Technical Service Bulletin

Subject: INSUFFICIENT A/C PERFORMANCE/LACK OF AIR BLOWING FROM VENTS/DUCTS	Bulletin No.: 07-004/21
	Last Issued : 10/08/2021

Description of the lot number on the evaporator temperature sensor:

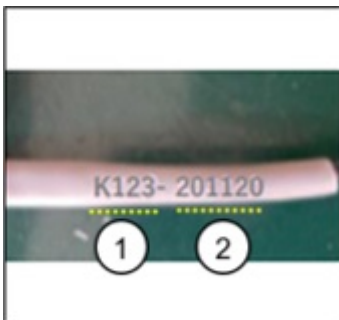
NOTE: The part number has not been changed for the modification. Identify modified sensors by the lot number on the protector tube of the sensor as shown below.

Modified parts: The lot number "K123-201120" (production date: November 20, 2020) and later are modified parts.

(1) First 4 digits of parts number **K123**-61-J22

(2) Production date in YYMMDD format.
"201120" means "November 20, 2020"
